Accession No. ML020170281

Response to Requests for Additional Information for request for unrestricted release of Building 26 from Veteran Affairs Permit Number 09-12467-02 located in Gainesville, FL.

Responses to Specific Items in NRC Request of December 7, 2009:

PIPE ASSEMBLY

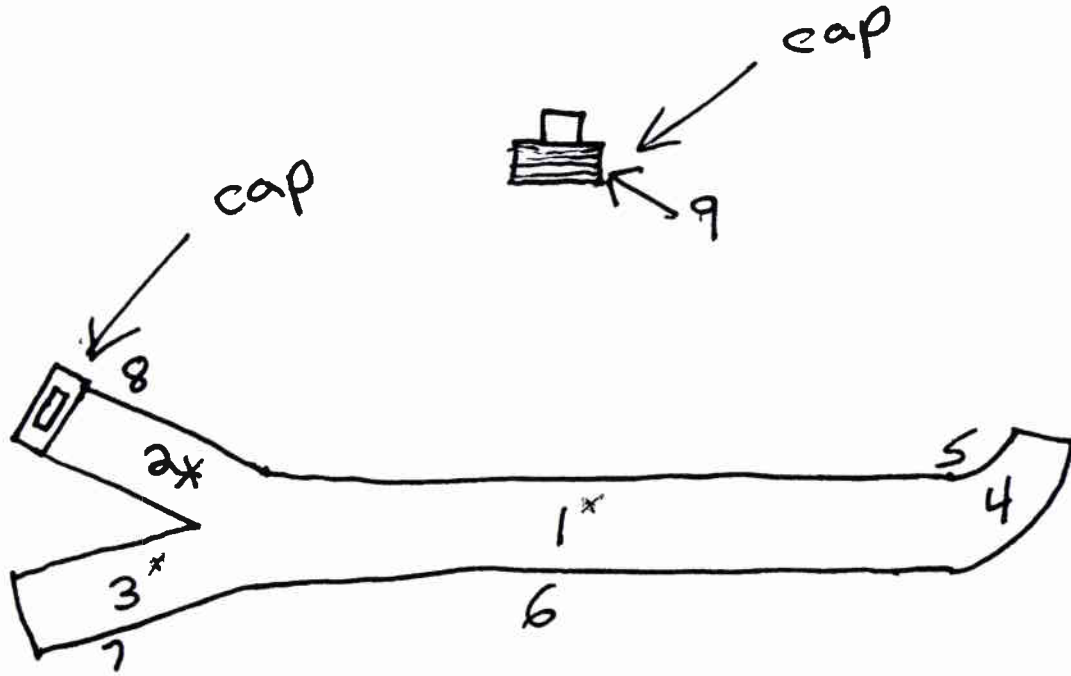
- e. *Response to NHPP's request for additional information dated October 5, 2005 [2009?] states no removable contamination was detected from the pipe. Were the wipes checked by a liquid scintillation counter? If so, provide liquid scintillation survey results.*

Response: See response to "c" above. In addition, we collected a new series of swipes (inside and out) for the removed section of pipe on December 15, 2009 and counted it in our Liquid Scintillation Counter on December 18, 2009 (see attachment). A few spots have elevated levels and we will store the removed pipe until the radiation levels decay to background and removable contamination is below the regulatory limits.
